Resolution 2006-83
CHRISTUS St. Vincent Regional Medical Center
Campus Master Plan

ST. VINCENT HOSPITAL CAMPUS MASTER PLAN

Case #2015-47. 455 St. Michaels Drive Christus St. Vincent Regional Medical Center Master Plan Amendments. WHR Architects, Inc., agent for Christus St. Vincent Regional Medical Center, request review and approval for Master Plan Amendments. (Dan Esquibel, Case Manager) (POSTPONED FROM JULY 2, 2015)

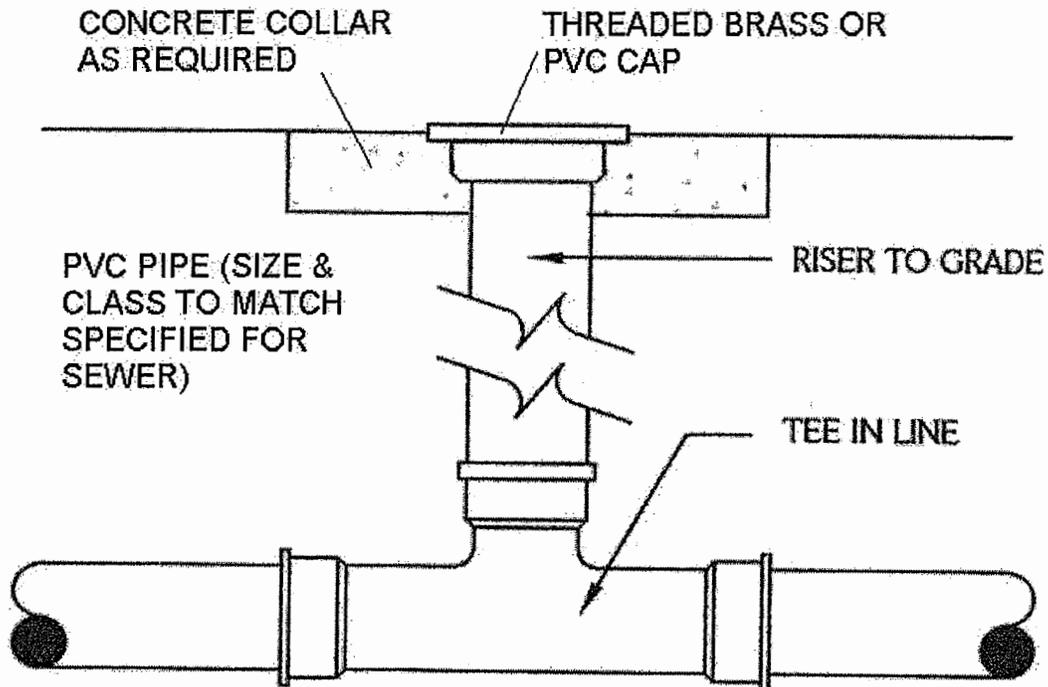
1. Add note to the Development Plan that Wastewater Utility Expansion Charge (UEC) shall be paid at the time of building permit application.
2. Add note to the Development Plan and the Utility Plans that the on-site sewer system serving the Development is private.

3. Identify the proposed on-site sewer lines as private on the Utility Plans.
4. Show the existing off-site public sewer line and easement on the Grading Plans. There may be required improvement to the public sewer line dirt access road outside of the new retaining walls on the southeast corner of the development.

5. City of Santa Fe sewer manhole covers shall not be used for the on-site sewer manholes. Indicate on the Utility Plans that the manhole covers are to be labeled "Private Sewer".

6. Industrial Pre-Treatment Sampling Ports (IPSP) are required and shall be shown on the Utility Plans. See attached detail.
7. Indicate on the drainage plans where the discharge points are located from the Development to help determine if the site discharge will impact the existing public sewer line and access

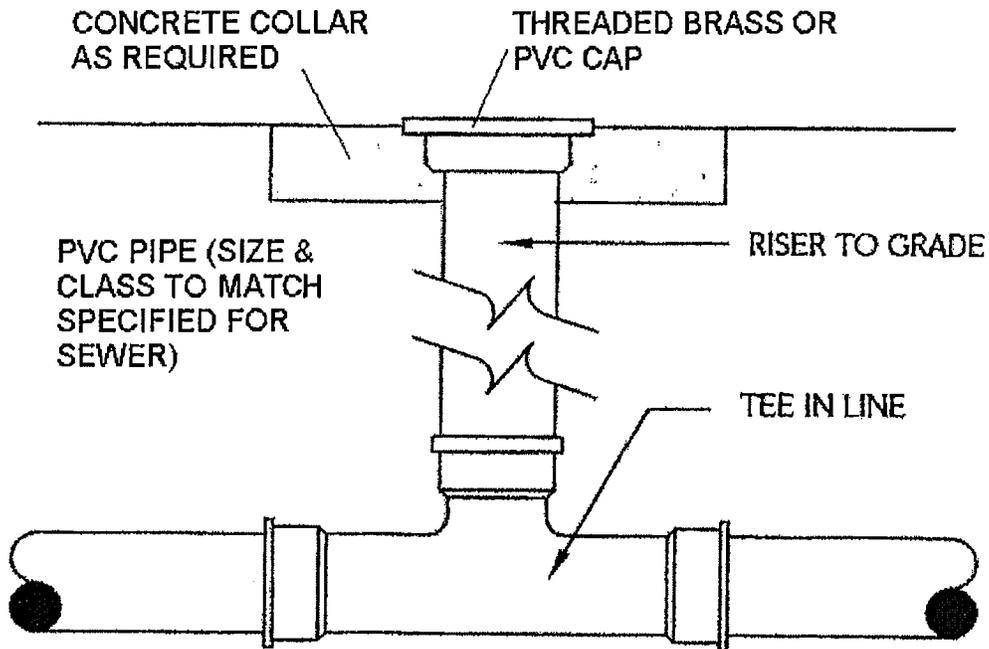
1. Add note to the Development Plan that Wastewater Utility Expansion Charge (UEC) shall be paid at the time of building permit application.
2. Add note to the Development Plan and the Utility Plans that the on-site sewer system serving the Development is private.

3. Identify the proposed on-site sewer lines as private on the Utility Plans.
4. Show the existing off-site public sewer line and easement on the Grading Plans. There may be required improvement to the public sewer line dirt access road outside of the new retaining walls on the southeast corner of the development.
